## **Statement of Basis**

**Permit to Construct No. P-2013.0063  
Project ID 61595**

**Commercial Creamery Company - Jerome Plant  
Jerome, Idaho**

**PROJECT:** P-2013.0063 PROJ 61595 – PTC Modification Application for Commercial Creamery Company – PM<sub>2.5</sub> and PM<sub>10</sub> Permit Allowable Emission Rate Increases for Dryers and NO<sub>2</sub> Emission Increases for Other Existing Emissions Units for the Facility Located in Jerome, Idaho.

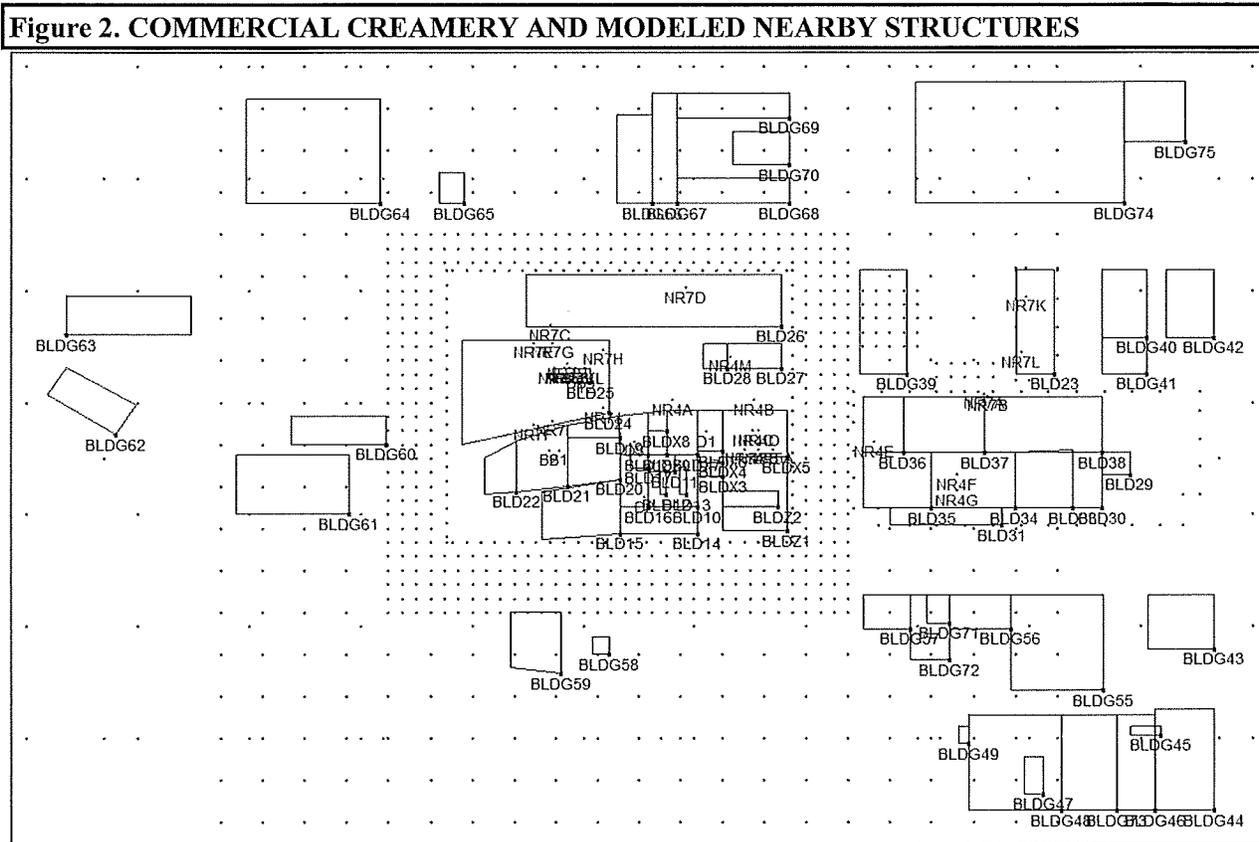
DEQ requested that the NAAQS compliance demonstration modeling documentation verify that all structures that could cause plume downwash be included in the impact assessment. EPA guidance has determined that emissions points within a distance equal to or less than five times the lesser of the building height or projected building width of the structure being examined could be subject to downwash caused by that structure. MEAS created a BPIP file with a number of structures surrounding the facility.

The locations of the structures appeared reasonably accurate when compared with the locations and dimensions represented in the Google earth® imagery. DEQ review concluded that the building downwash was appropriately evaluated.
